## HISTORIC AND DESIGN REVIEW COMMISSION

**HDRC CASE NO:** 2020-584  
**ADDRESS:** 1235 E CROCKETT ST  
**LEGAL DESCRIPTION:** NCB 1373 BLK 1 LOT S 125 FT OF 27  
**ZONING:** RM-4, H  
**CITY COUNCIL DIST.:** 2  
**DISTRICT:** Dignowity Hill Historic District  
**APPLICANT:** Kali Tripp/Tripp Flip, LLC  
**OWNER:** Kali Tripp/Tripp Flip, LLC  
**TYPE OF WORK:** Porch and porch roof modifications  
**APPLICATION RECEIVED:** December 18, 2020  
**60-DAY REVIEW:** Not applicable due to City Council Emergency Orders  
**CASE MANAGER:** Edward Hall

### REQUEST:

EXTERIOR ELEVATIONS

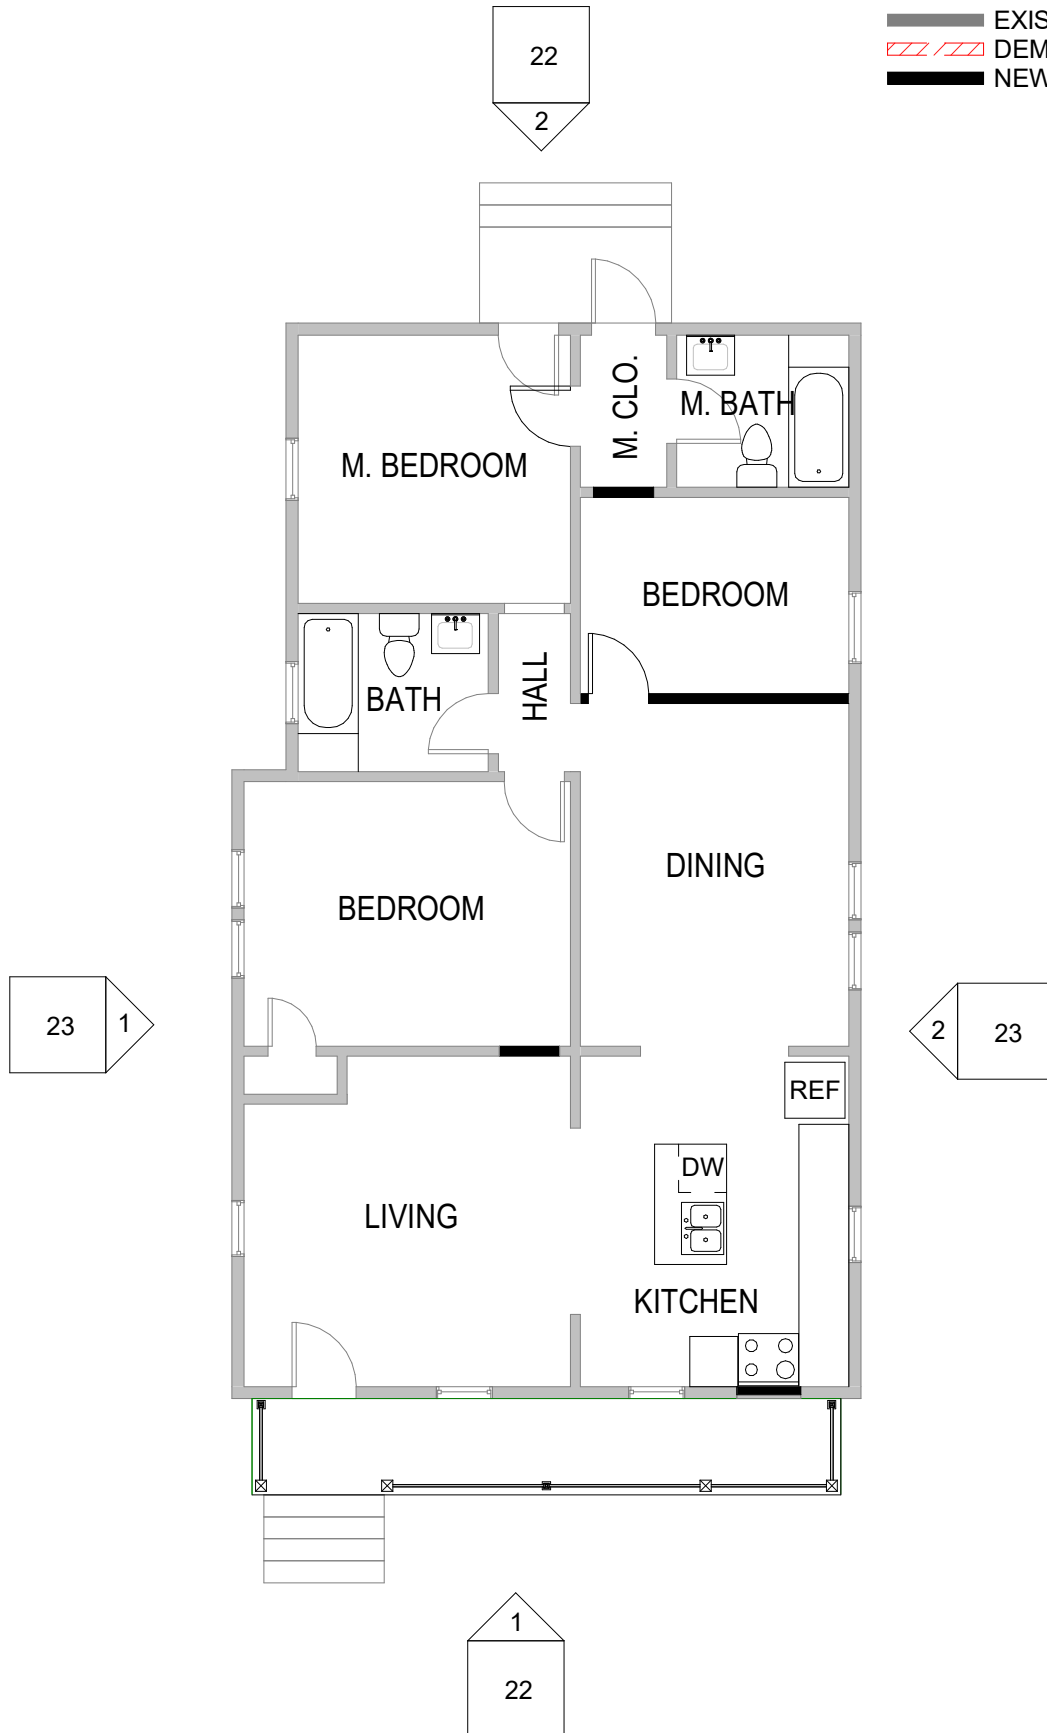
- c. PORCH CONSTRUCTION – The applicant has proposed to eliminate the eastern most porch and to construct a new porch to span the approximate width of the historic structure. The applicant has proposed to maintain the existing western porch steps. Per the Guidelines for Exterior Maintenance and Alterations 7.A.i., front porches should be preserved. While the applicant has proposed to modify the porch from its original profile, staff finds that due to the preservation of the two front doors, the structure's previous use as a duplex will still be evident. Staff finds that the proposed columns should be six inches square and feature capitol and base trim. Additionally, the proposed porch railing should be consistent with staff's specifications, featuring a 2x4 top rail, 1x2 trim beneath the top rail, 1 ½" x 1 ½" square pickets, and a notched 2x4 bottom rail. The bottom rail should be approximately 3.5 inches above the porch decking. Porch decking shall feature 1x3 porch decking, installed perpendicular to the front façade.

- d. PORCH ROOF CONSTRUCTION – The applicant has proposed to modify the existing, two porch roofs and construct one single porch roof to mirror the dimensions of the proposed porch, described in finding c. Generally, staff finds the proposed porch roof to be appropriate.

- i. That the proposed columns should be six inches square and feature capitol and base trim.
- ii. That the proposed porch railing features a 2x4 top rail, 1x2 trim beneath the top rail, 1 ½" x 1 ½" square pickets, and a notched 2x4 bottom rail.
- iii. That the porch feature decking that features 1x3 members installed perpendicular to the front façade.
